Re: Allaso Olivine/ 6925 Alameda Blvd. NE

**Request for Certificate of Occupancy**

Transportation Inspector
City of Albuquerque
Re: Traffic Certification for Certificate of Occupancy for Allaso Olivine, All Phases

TRAFFIC CERTIFICATION FOR ALLASO OLIVINE BP-2022-40325

**AS101**

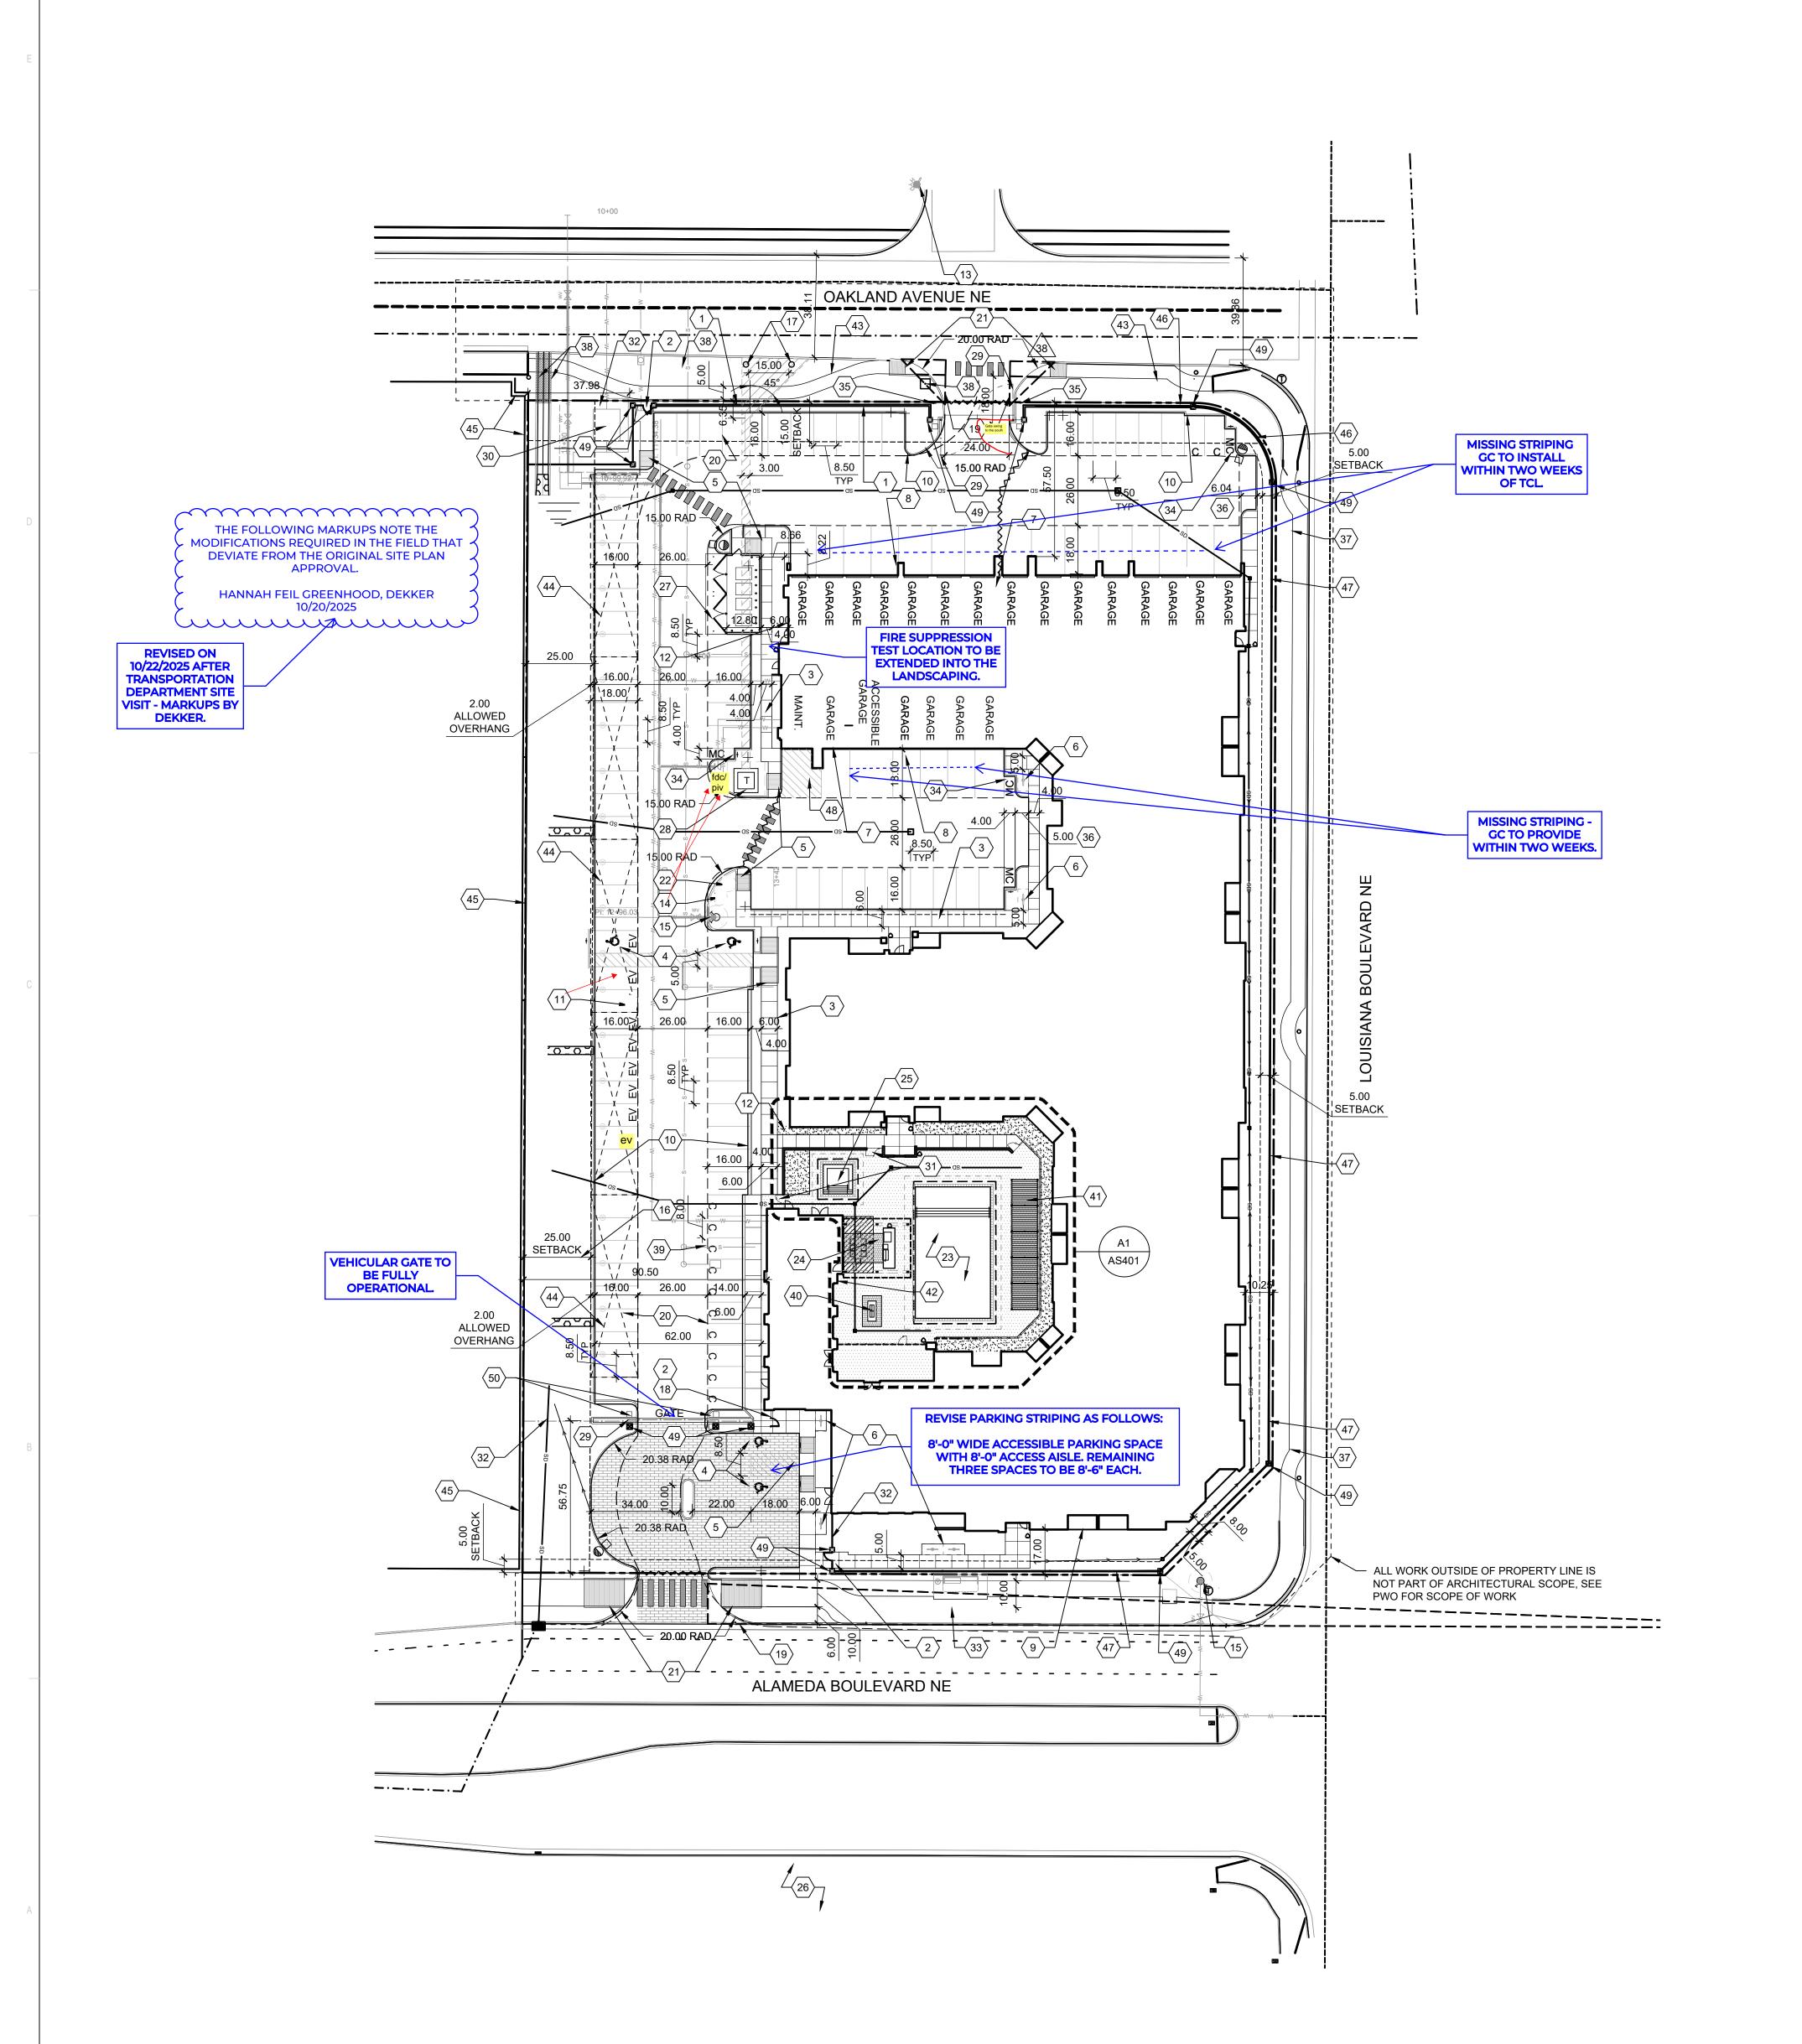
- 1. See attached markups on AS101 for as-built conditions that deviate from the original approved plan, but still meet requirements of the primary approval and have been reviewed in the field by inspectors as noted by the General Contractor:
  - a. Relocation of EV parking space, as shown.
  - b. Relocation of PIV and FDC, as shown.
  - c. Gate swing adjustment, as shown.
- 2. Items pending by the general contractor that have been confirmed to be completed by October 29, 2025:
  - a. Complete missing pavement markings at garage tandem spaces, as shown.
  - b. Revise parking striping as directed by Dekker to ensure two accessible spaces and access aisle are 8'-0" wide and align with accessible ramp at front entry.
